The proposal seeks planning approval for a 4-lot subdivision at 274 Perth Mill Road, Perth.

PROJECT: 4 LOT SUBDIVISION SCALE: 1:500 SHEET SIZE: A1 DWGs IN SET: rarein.com.au P. 03 6388 9200 ADDRESS: 274 PERTH MILL ROAD, PERTH PROJECT No: 231005 DWG No: C401 REV: 0

Additional Information Required for Planning Application PLN-22-0188 4 Lot Subdivision at 274 Perth Mill Road, Perth

TITLE: CIVIL WORKS PLAN

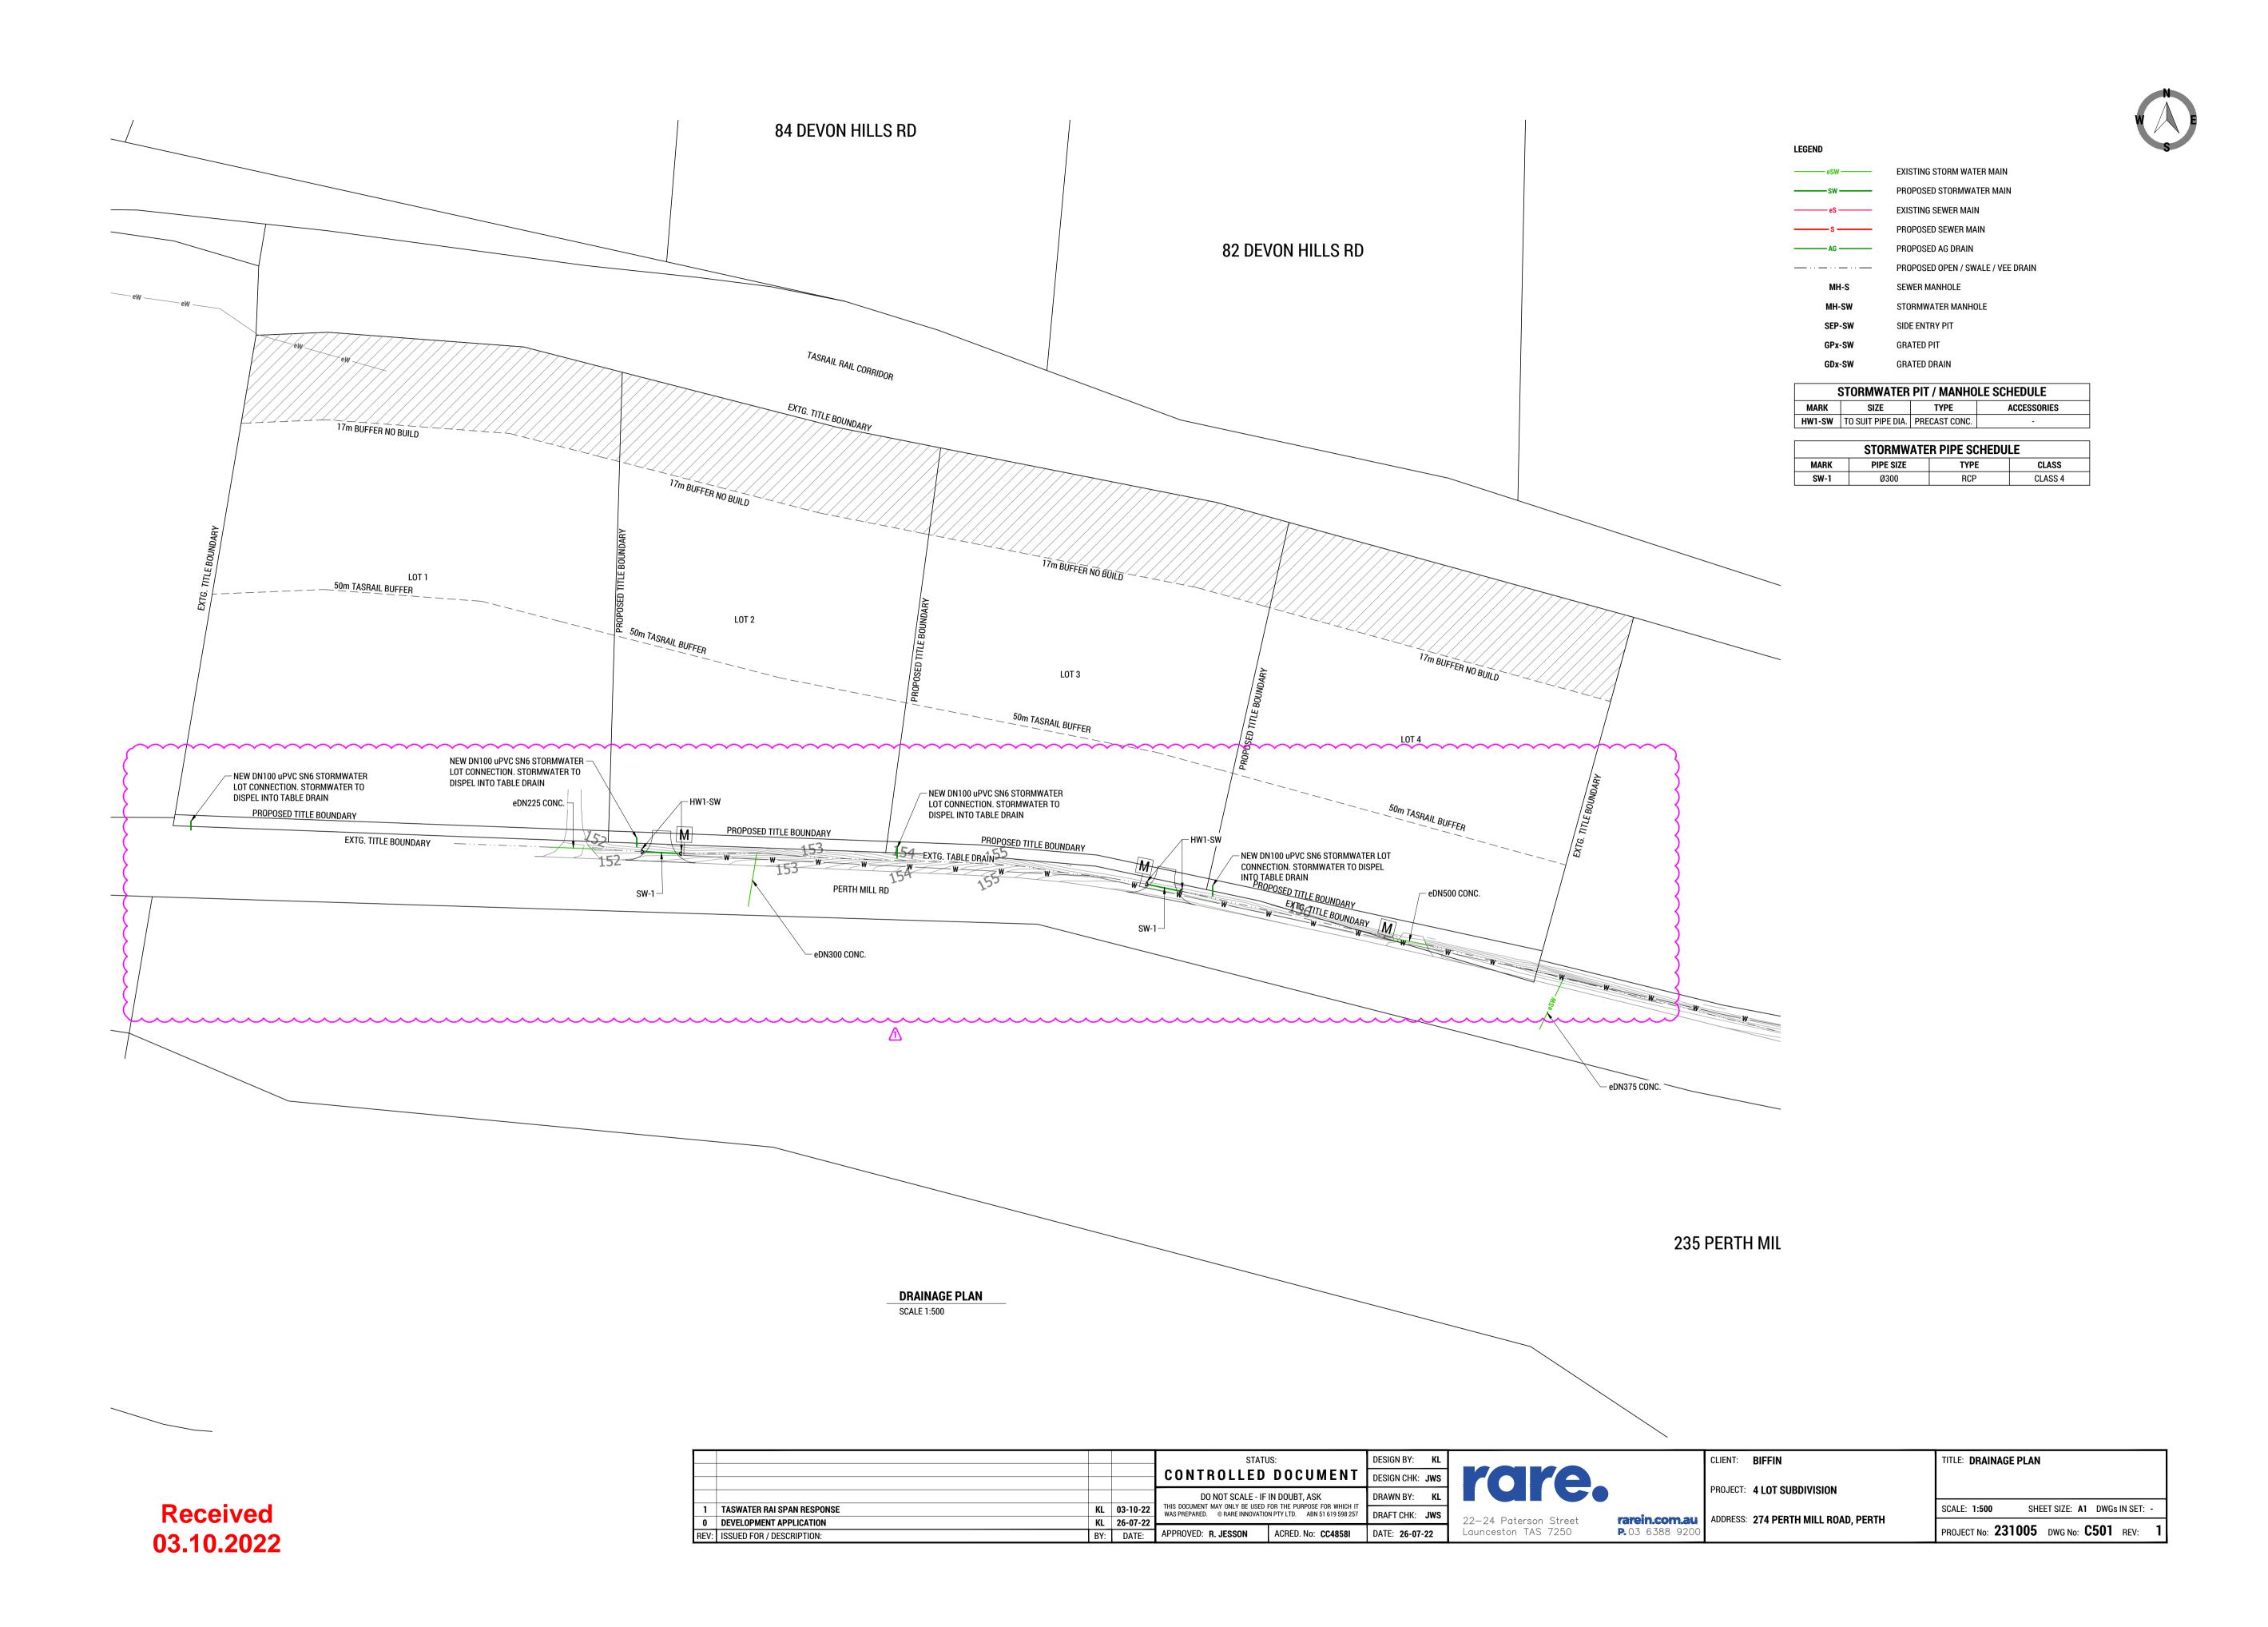
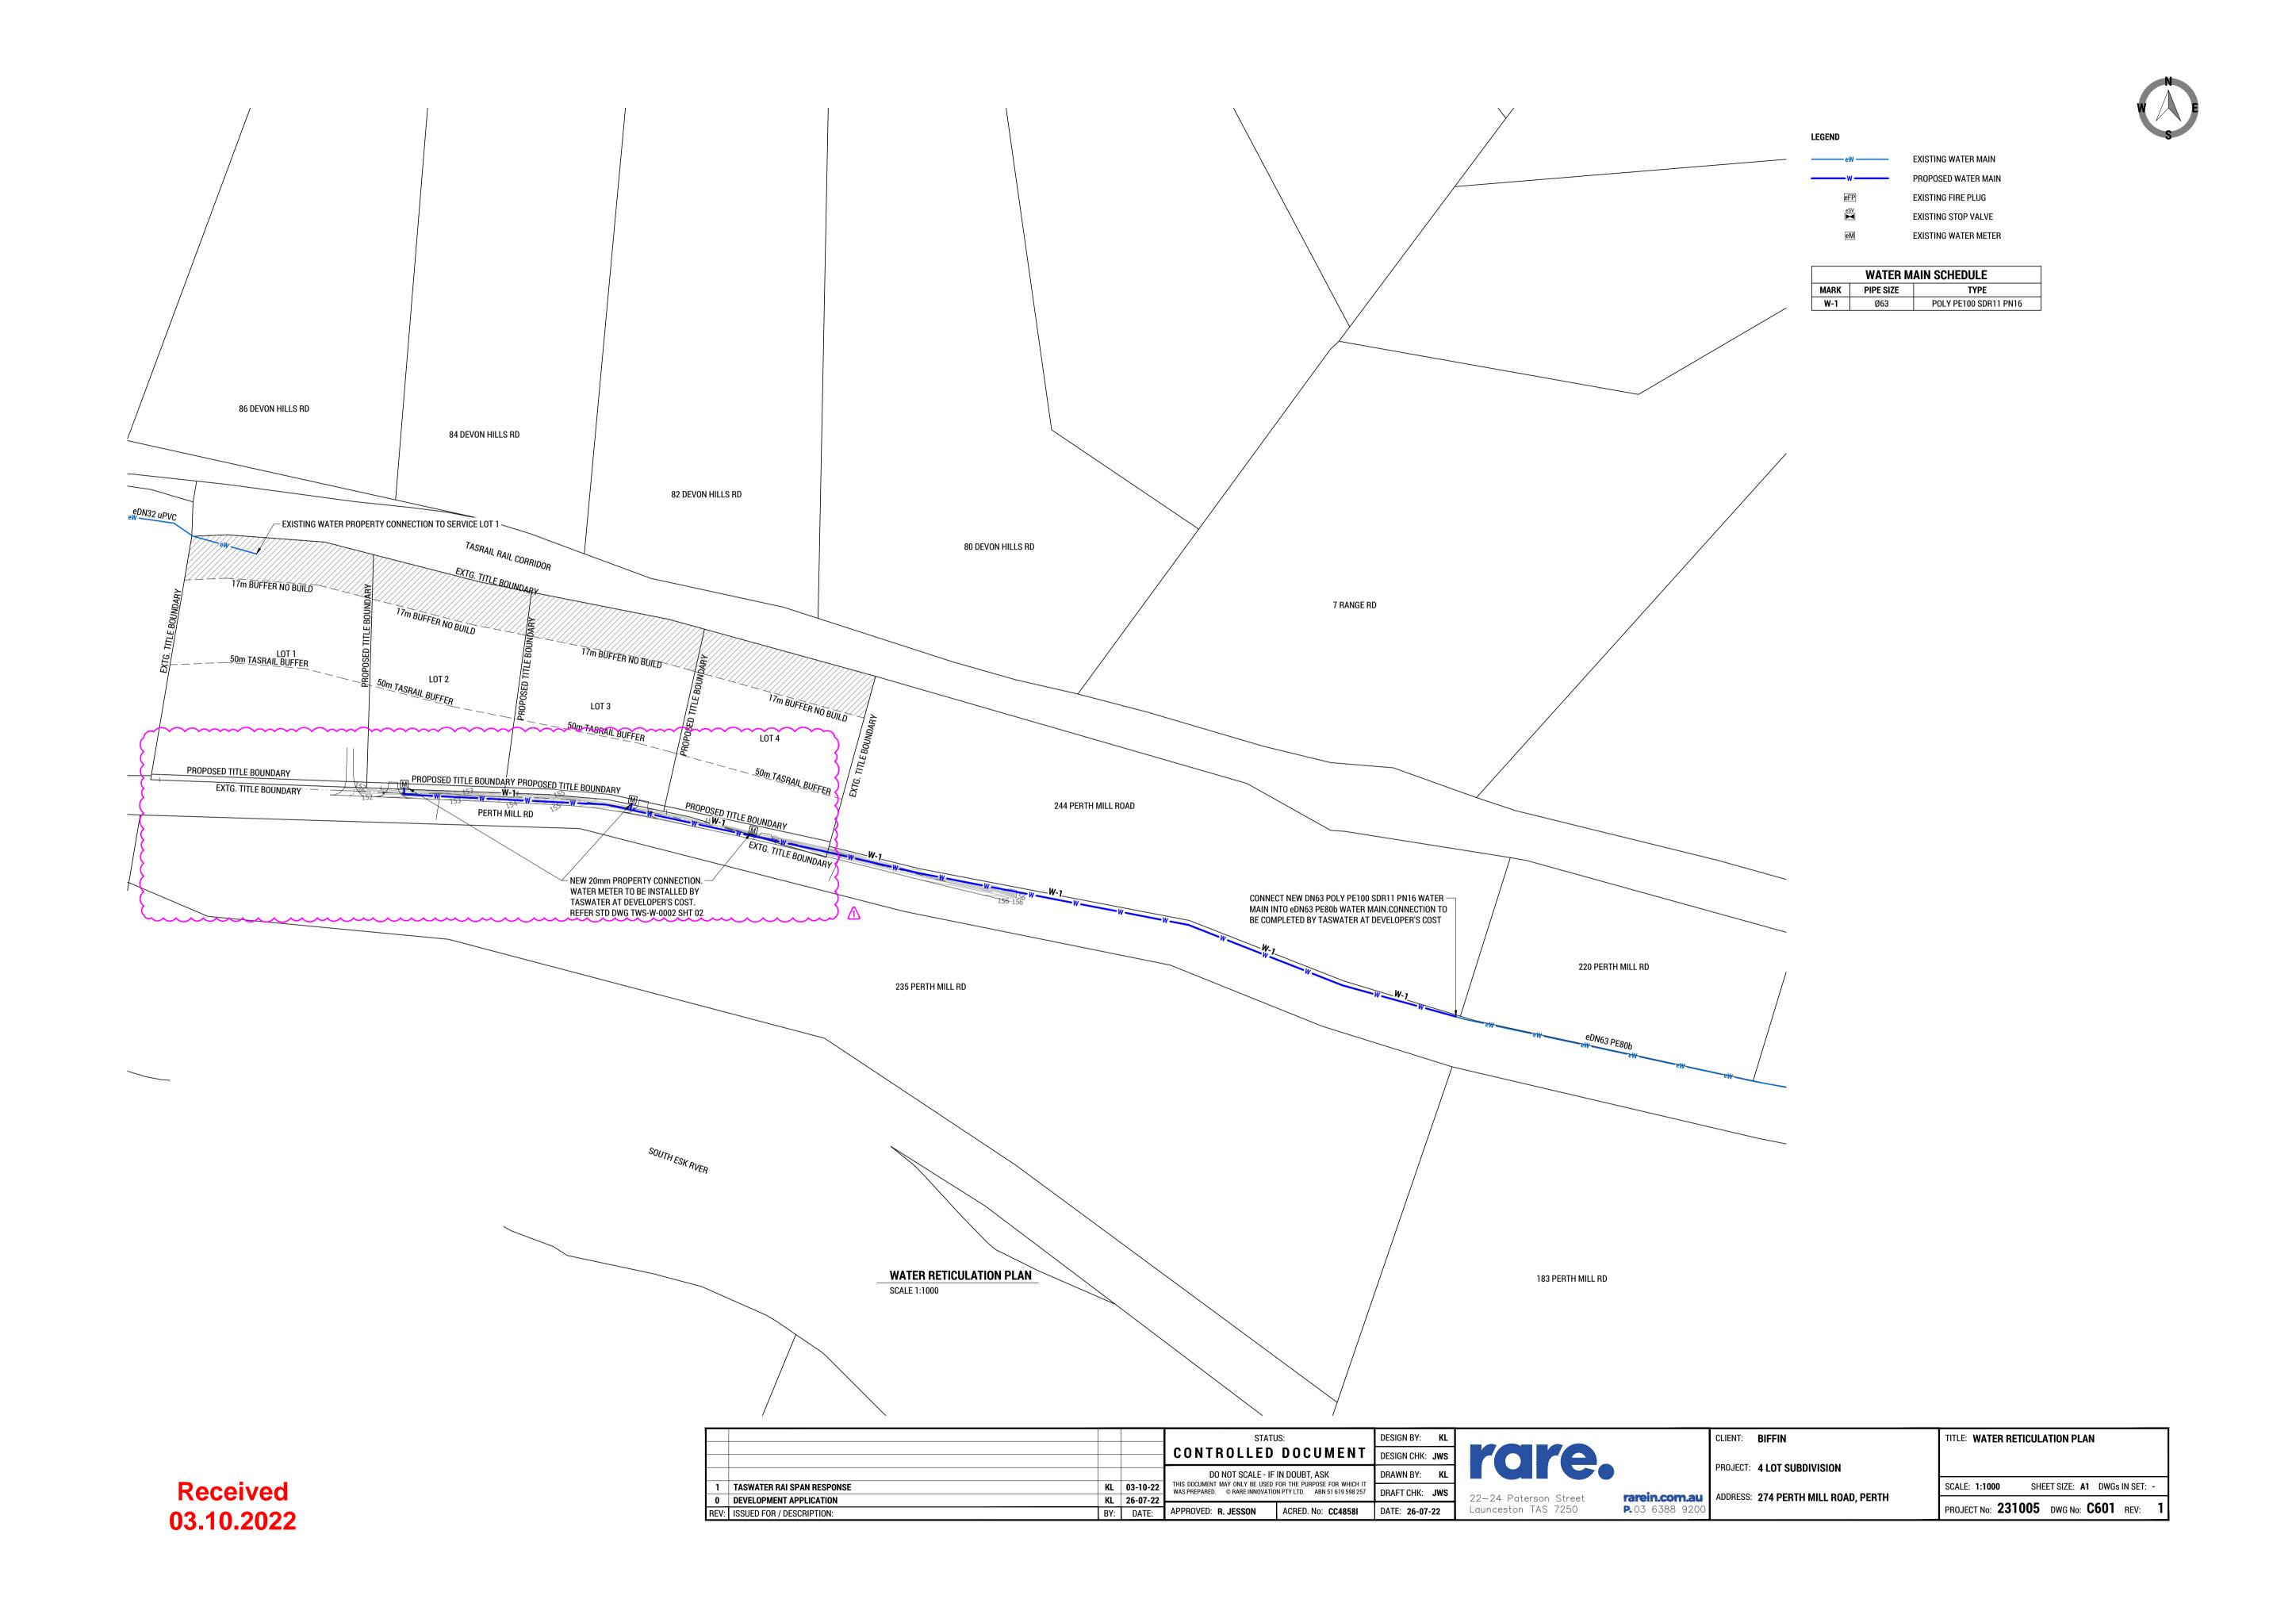
- On the proposed concept plans by Woolcott Surveys shows a section on DN63 water main in front of 244 PERTH MILL RD and it is unclear if this is proposed or existing. Please clarify and provide details. Advice: It is noted that no nearby developments have reached Practical Completion and therefore TasWater has not accepted ownership of these assets. Neighbouring developments will need to be completed, finalised and accepted before any connections can be made.

- 2. The existing DN63 main on PERTH MILL RD has reached its design capacity and the following will need to be required;
 - a. Plans that show an upgrade of the existing DN63 to DN100 approx 380M from the existing DN100 main further down Perth Mill Rd past the last existing connection.
 This is to ensure adequate supply to this development and no detriment to any existing connections. Or;

Schedule of drawings/documents			
Prepared by	Drawing/document No.	Revision No.	Date of Issue
Rare	Project: 231005 Sheets: C401, C501, C601, C701	1	03/10/2022

- A suitably sized water supply with metered connections to each lot of the development must be
 designed and constructed to TasWater's satisfaction and be in accordance with any other conditions
 in this permit.
- 2. Any removal/supply and installation of water meters and/or the removal of redundant and/or installation of new and modified property service connections must be carried out by TasWater at the developer's cost.
- 3. Prior to commencing construction of the subdivision/use of the development, any water connection utilised for construction/the development must have a backflow prevention device and water meter installed, to the satisfaction of TasWater.
